Historic Preservation Commission

October 25, 2018

Certificate of Appropriateness

Certificate of Appropriateness

NORTH ELEVATION

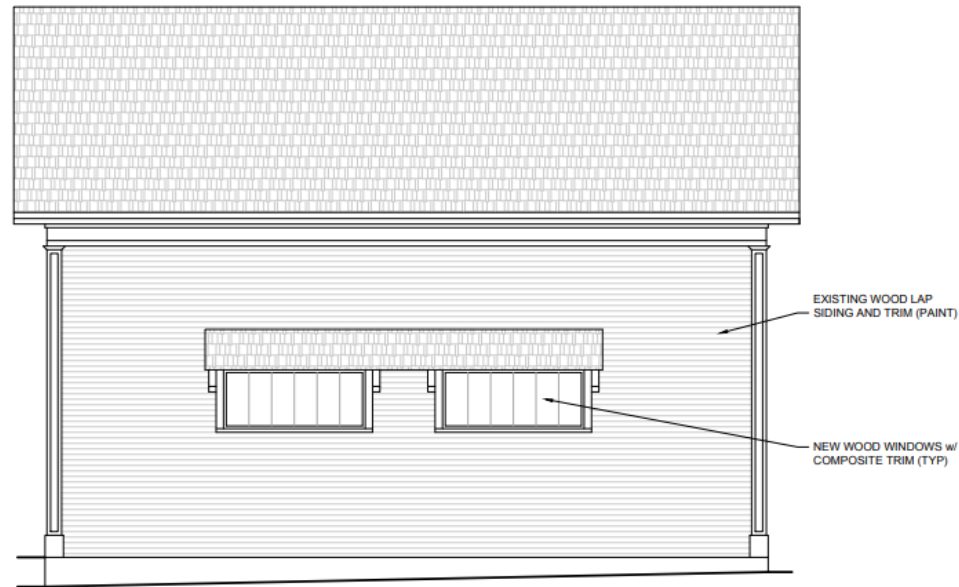
- Carriage house built in 1910
- Convert two-story carriage house into office space
 - Close the overhead door (not original) and replace with new wood windows and entry door
 - Add exterior access to second level

- Replacing windows with new wood windows with composite trim
- New stairs to second floor will be composite material with aluminum railing

- Approve as submitted
